CWSP SYSTEM HARDENING FIELD SCOPING DOCUMENT

PM: 35191383	Project Name: ECOP - SILVERADO 2102 - H01-LR58626	
Notification: 119518528	Region: Bay Area	City: Saint Helena
Project Manager: [REDACTED]	Division: North Bay	County: Napa

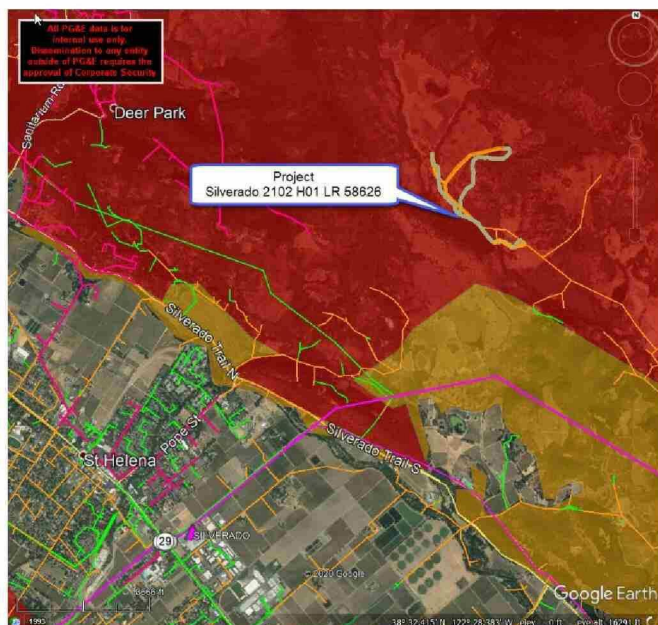
- Silverado 2102 project is surrounded by grass oak woodland and some small pockets of brush. There is one small agricultural areas to the Southeast on the project
- The population density is considered low due to rural ranch/farm type setting of the area.

Fire History:

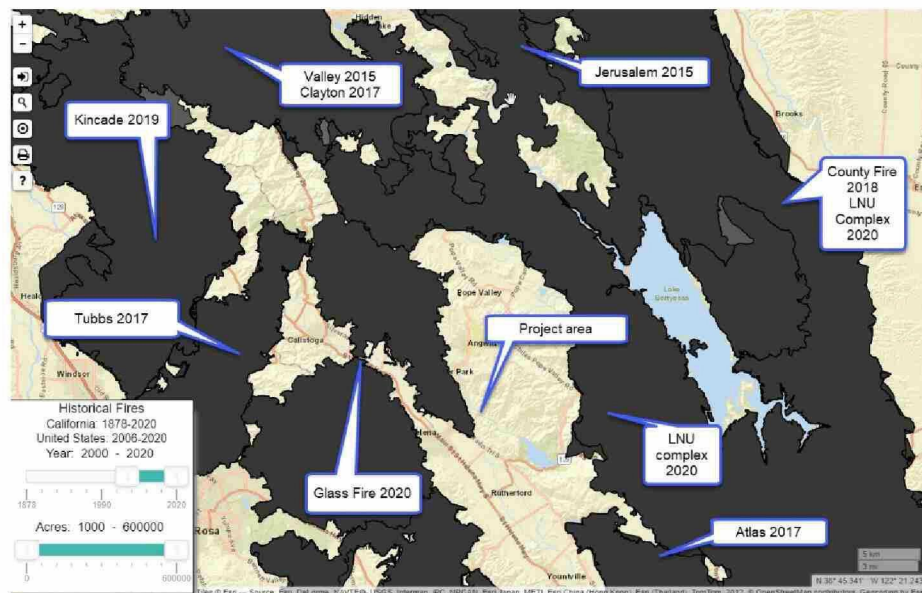
- This area has significant fire history directly impacting the project area. These fires include the Glass and LNU Complex of 2020, Kincade Fire of 2019, County Fire 2018, Atlas, Tubbs and Nuns Fires of 2017, Rocky, Valley, and Jerusalem of 2015.

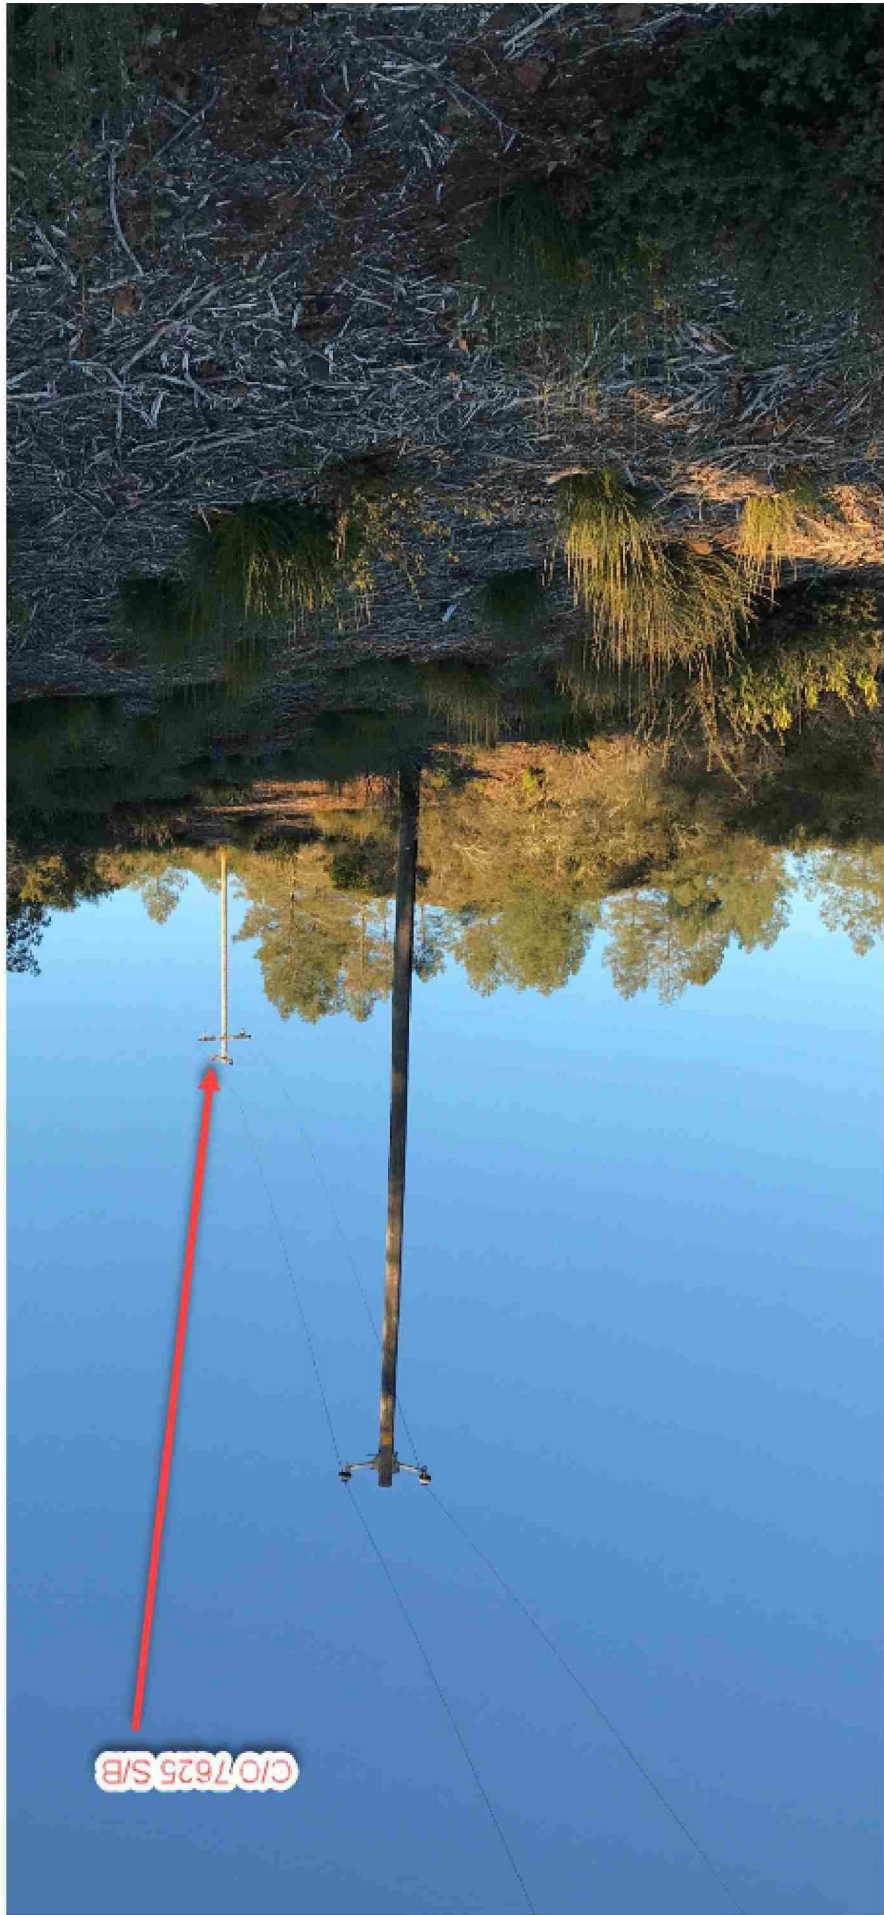
Existing line has limited tree exposure through mature pine & oak trees. Taller poles will move covered conductor above tree line.

SAP Equip. ID (Start)	SAP Equip. ID (Finish)	OH, Trench, Bore, Plow-in	OK to Proceed (Y,N, N/A)	Field or Engineering Notes*
102264528	102264534	OH	N	[REDACTED] This location was field checked on 12/23/20. Estimating as determined that it is possible for this line to be relocated but doesn't feel like it would be a benefit. Relocation would result in removal of 4 poles and installation of 4 poles removal of 1700' of oh line and installing 1200', 500' less. New route may cross 4 properties and require new easements. If relocation is chosen, project management would need to reach out to property owners prior to start of job.

█ This location was field checked on 12/23/20. It is my recommendation that the entire line be hardened in place. I don't foresee any estimating hang-ups with this option.
